## The Future For Uplift On Cairngorm â?? Environmental Aspects

With the Funicular currently out of action and its future unknown, the recently published SE Group addendum into uplift a Cairn Gorm ([see here](#)) is ostensibly recommending the creation of **8.7 hectares** of new ski terrain in Coire Cas as part of their revised plans. This post explains why this figure is wrong and far more ground will be affected.

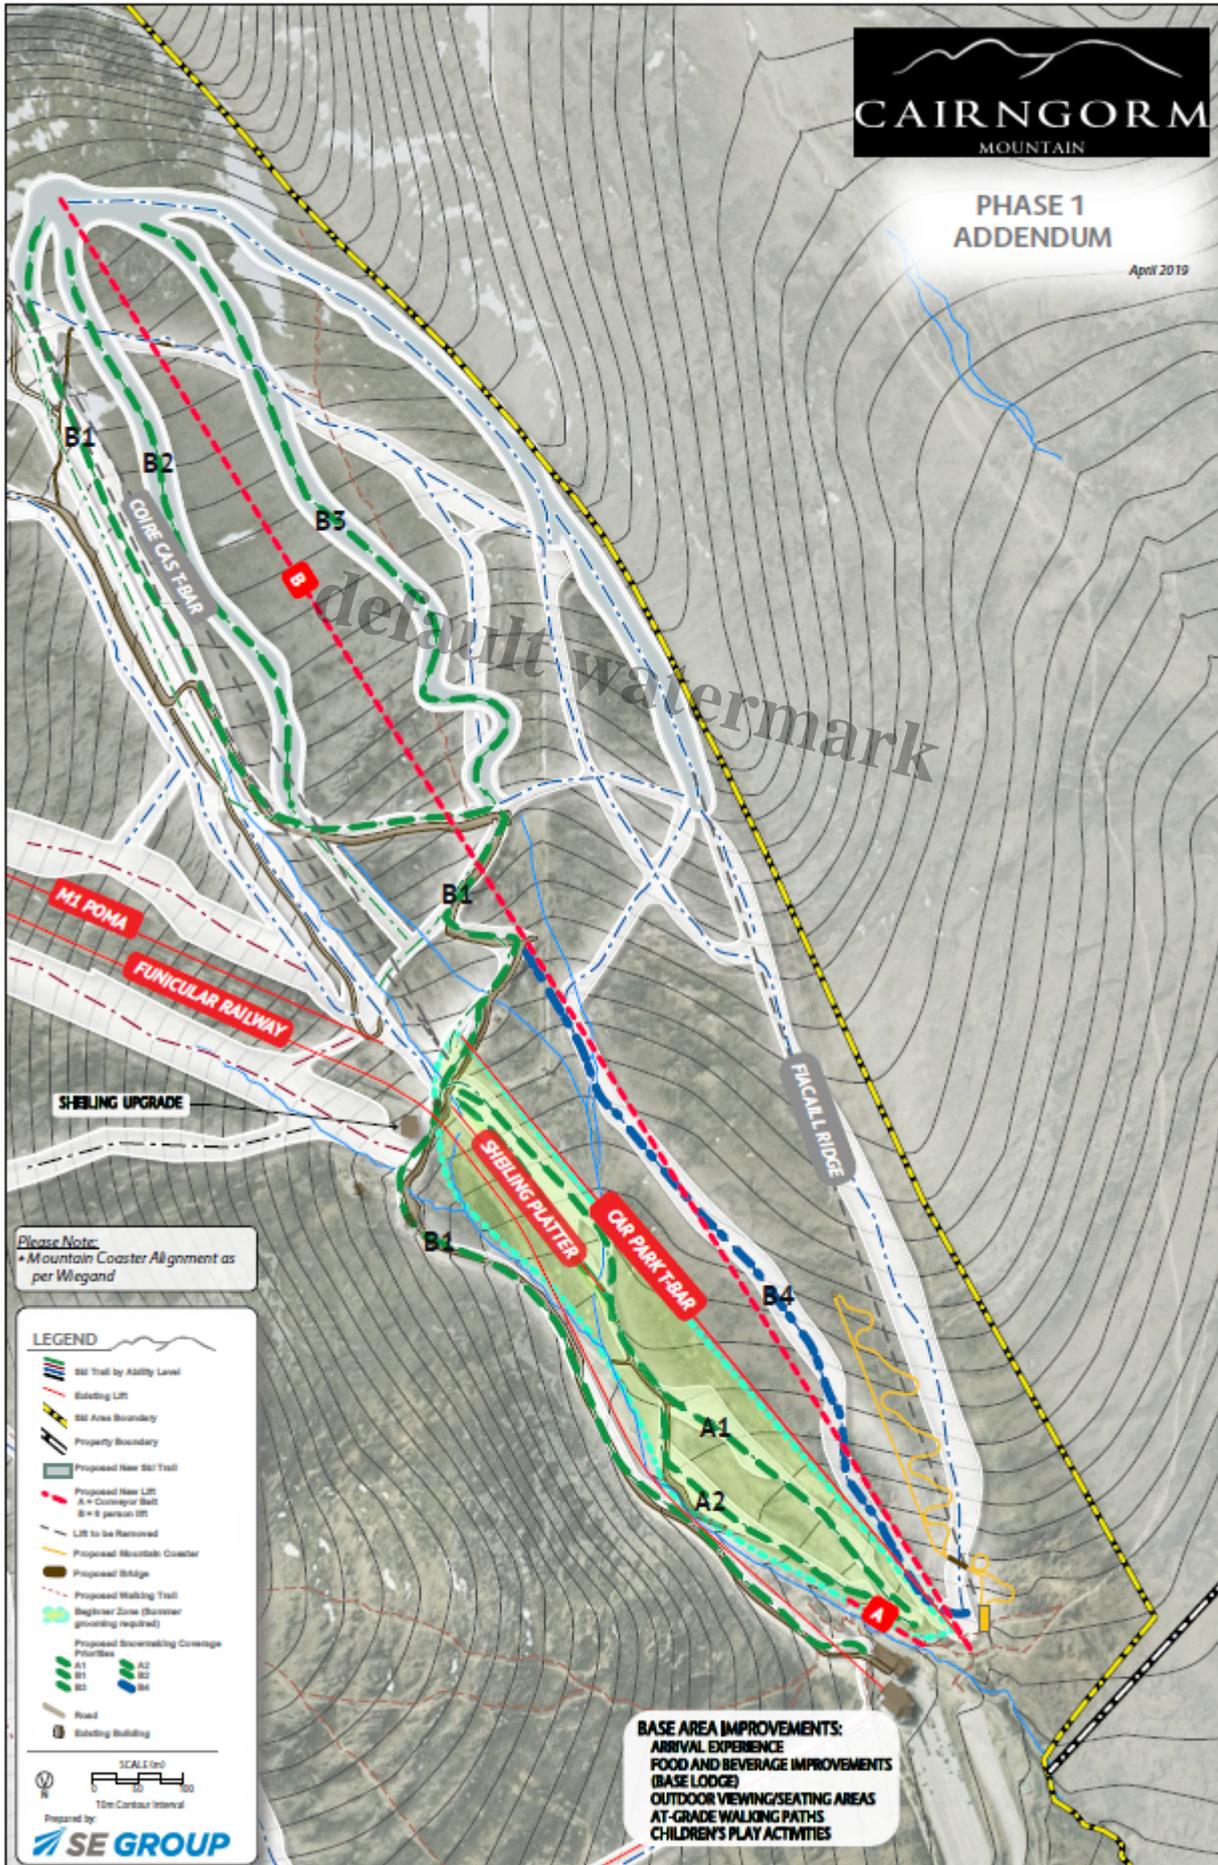
Looking at the second table on terrain costs there is no figure for the size of the beginner zone, so I had assumed from the Snowmaking chart that it is 3.1 hectares or 31,000 sq. m. I have now done a rough measurement of the size of the beginner zone and found it is probably over **6 hectares or 60,000 sq. m.** This would alter the row for Total of New Terrain, including the beginner zone, to approx. **15.0**

**hectares or 150,000 sq. m.**, not 8.7 hectares, (strangely enough the area proposed for snowmaking is 15.9 hectares), and a capital cost of **Â£525,000** not Â£404,410.

If we take a look at the map of the proposals, its very poorly labelled. The "new terrain" at the "top of B1" referred to in the table presumably means the area from the top of Lift B to the top of the current Cas tow.

Runs B2 and B3 are completely new terrain and have dimensions, by my measurements, of approximately (B2) 700m long x 34m wide, and (B3) 800m x 35m, which comes to about what is quoted in the table. However, while B2 is 2.4 hectares it needs 2.7 hectares of snowmaking, whereas B3 is larger at 2.8 hectares and yet only requires 2.4 hectares of snowmaking!

The status of run B4 on the map is unclear because although it is shown as an existing run there is nothing on the ground where it is depicted. The snowmaking table describes it as comprising 2.9 hectares or 29,000 sq. m. If that were added to the new terrain table, that would increase the "total of New Terrain" to almost 18 hectares or 180,000 sq. m. and the capital cost to £630,000.

B5 is not shown on the map either but appears to run from the top of lift B to... where exactly? The table describes it as "connecting to Fiacaille ridge" but from the size and colour of the area shown on the map it appears that it should have been described as "connecting to the top of the Fiacaille Ridge to...". Not quite the same!

Correct me if this already exists, but the map is also showing a run that starts off from the top part of the Fiacaille Ridge to... up track for about 1/3<sup>rd</sup> of its length but then veers off to one side only rejoining near the bottom of the lift! Is this new terrain as well? If it is then it has not been included in the new terrain figures and, as it looks roughly the same size as B5, could add another 32,000 sq. m. at a cost of £112,000 giving a "total of new terrain" of about 212,000 sq. m. and a capital cost of £842,000.
